Mackenzie
DISTRICT PLAN REVIEW
TOMORROW'S MACKENZIE
KA AWATEA HŌU

Section 42A Report: Plan Change 23 – Natural Character, Natural Features and Landscapes and General Rural Zone

Reply Report

Date: 14 June 2024

Figure 1: Existing commercial forestry in the vicinity of Lake Ōpuha located outside proposed ONL/FMA.

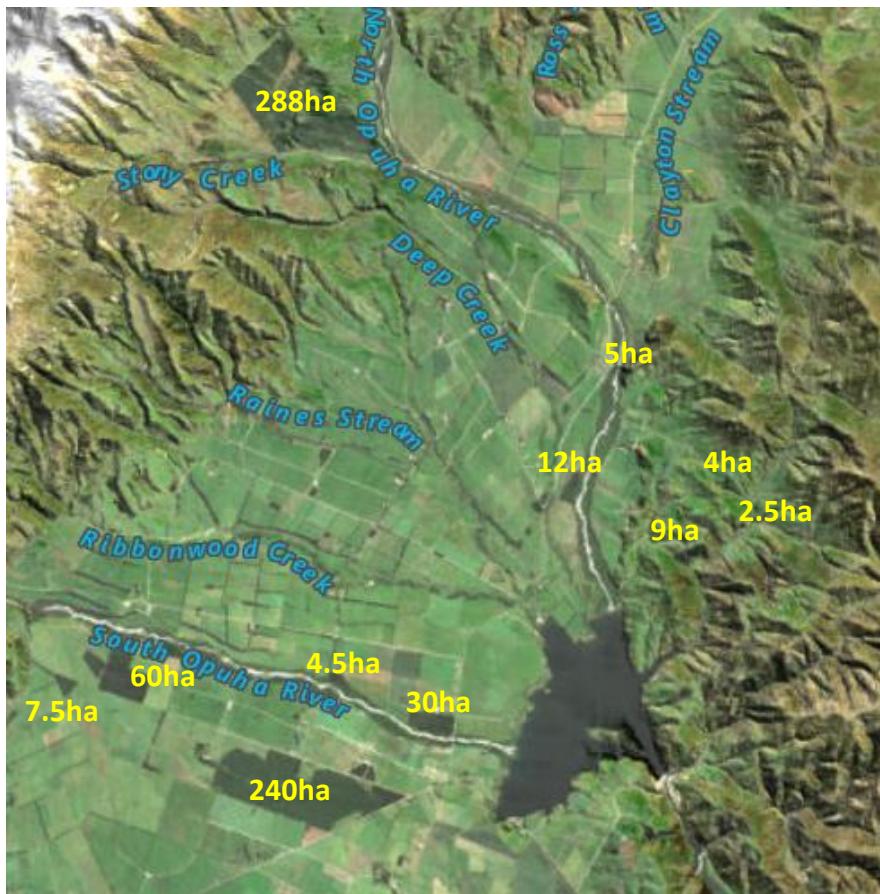
17. The submitter sought that reference to Lake Ōpuha is added to **GRUZ-R13.4**, which relates to the protection of the Timaru Urban Catchment from the effects of forestry³. This would mean all forestry greater than 2ha in any five year period within the Lake Ōpuha catchment would require resource consent.

18. It is noted that the submitter has not defined the size of the Lake Ōpuha catchment that would be impacted by the proposed amendment to **GRUZ-R13**. Notwithstanding, it would appear to cover a very large area of the Eastern District, including the northern part of Ashwick Flat, the Sherwood Range, Claytons Range and Four Peak Range. Whilst the higher elevations are included in either ONL or FMA where commercial forestry is otherwise controlled, I am concerned that the proposed change would mean that anything other than small scale forestry would require consent across much of the District remaining outside those areas.

19. The aerial photograph below illustrates the extent of existing commercial forestry within the catchment of Lake Ōpuha, this is somewhat at odds with the response provided at the hearing.

20. Based on the current level of knowledge regarding the scale and extent of the catchment and therefore the implication of including Lake Ōpuha within **GRUZ-R13.4**, I recommend that this change is not made.
